Addendum #1

Project Name:	Centennial Park Improvements - Phase 0.5
Bid Number:	FD21-02-028
Date:	February 22, 2021
Project Manager:	Brian Ward

CENTENNIAL PARK: PHASE 0.5 ADDENDUM

**STOP & WASTE VALVE ASSEMBLY
WITH BACKFLOW PREVENTION ASSEMBLY**

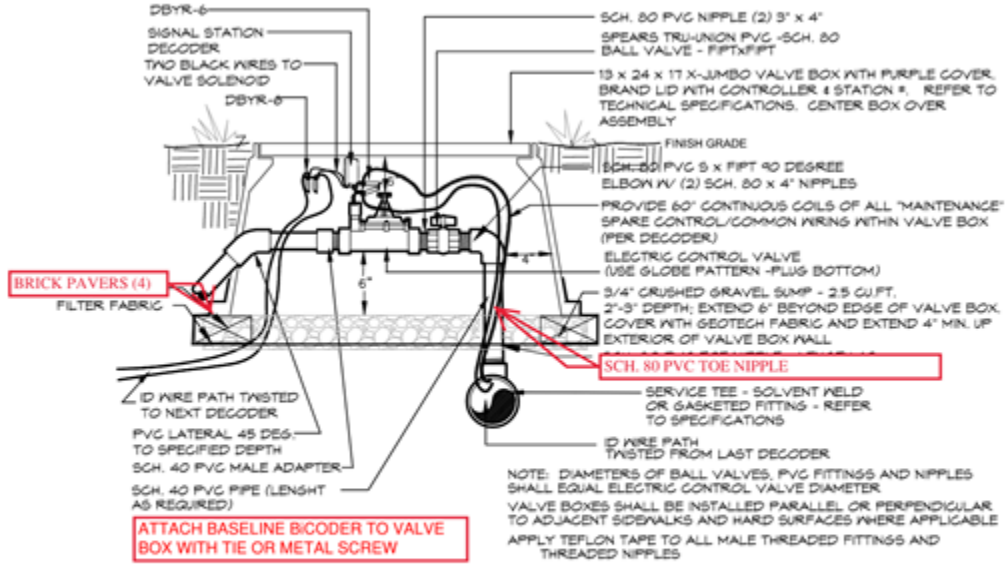
1. Remote control valve E-25: Include additional 1" lateral piping (~500'), flush valve assemblies (4) and inline drip tree rings to 25 trees.
2. Include two additional soil moisture sensors (total of 3).
3. Change pop-up height for spray sprinklers in the tree lawn along 23rd Ave. to 12" pop-up height.
4. Remove air vacuum relief valve assembly
5. Change Rain Bird 5004 to 5006 (6" pop-up height)
6. Replace Winterization Detail and Backflow Detail with new Backflow Detail

ELECTRIC CONTROL VALVE -1"-2 1/2"
WITH DECODER

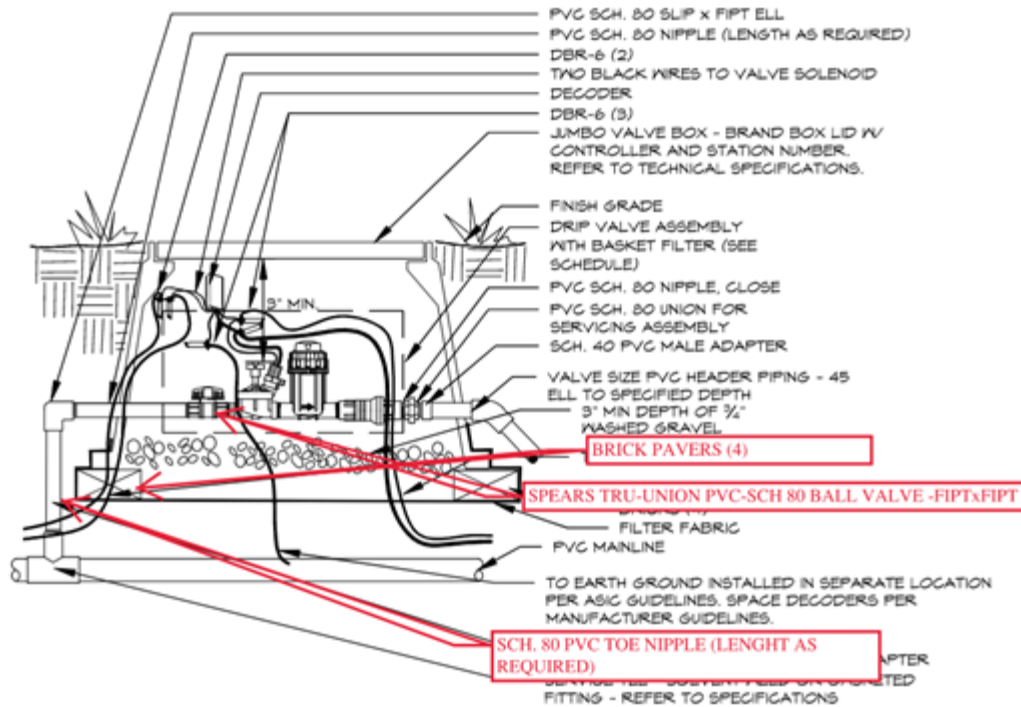
7. Replace Remote Control Valve Assembly Detail with new Remote Control Valve Assembly Detail

DRIP VALVE TWO-WIRE SYSTEM

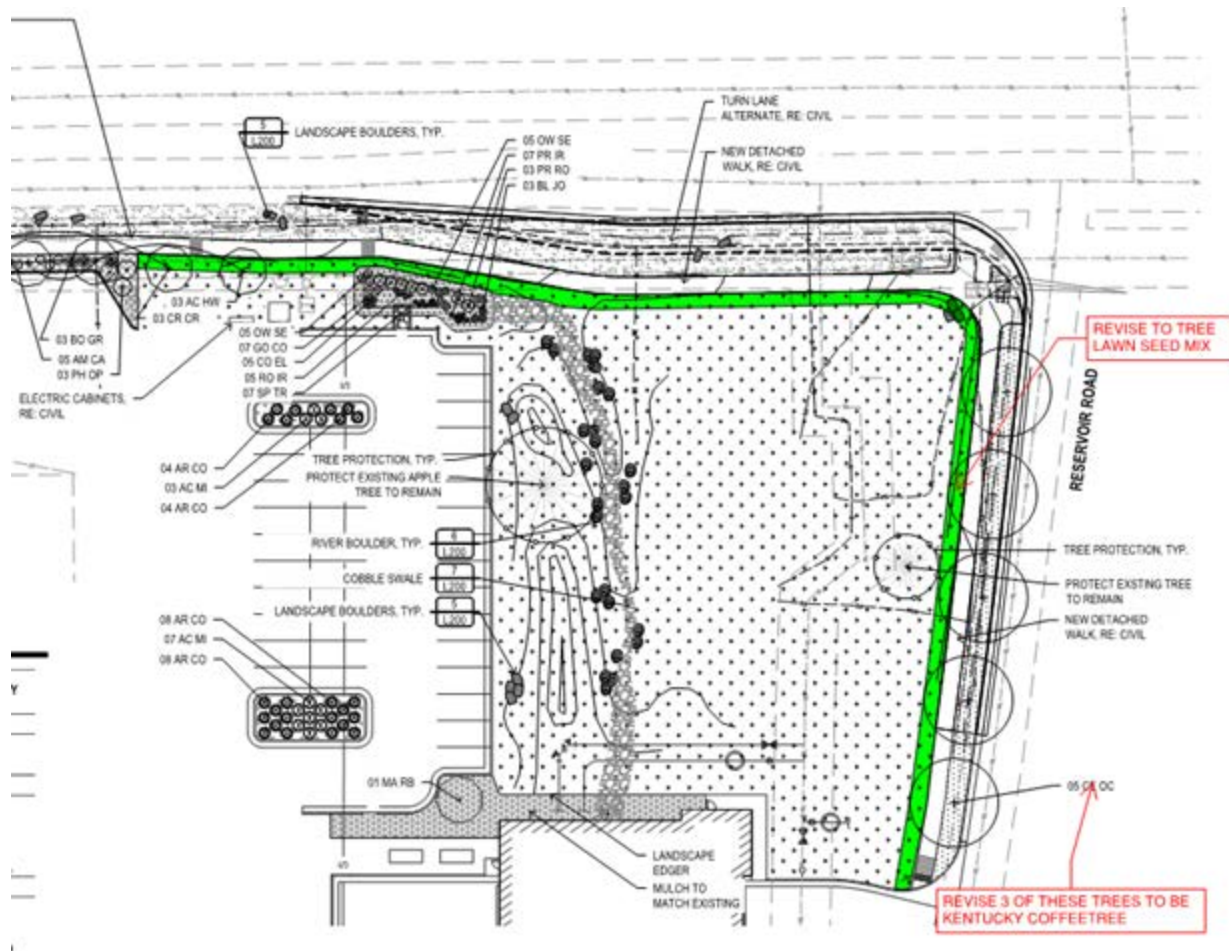
8. Replace Drip Remote Control Valve Assembly Detail with new Drip Remote Control Valve Assembly Detail

INSTALL ASSEMBLY TO REST ON GRAVEL SUMP, CONTAIN ENTIRE ASSEMBLY WITHIN BOX. NO VALVE BOX EXTENSIONS WILL BE ACCEPTED. PROVIDE 3"-4" CLEARANCE BETWEEN TOP OF CONTROL VALVE SOLENOID AND BOTTOM OF VALVE BOX LID. TOP OF VALVE BOX TO BE FLUSH WITH FINISH GRADE. VALVE BOX SHALL NOT REST ON DRIP TUBING.

ATTACH BASELINE BICODER TO VALVE BOX WITH TIE OR METAL SCREW
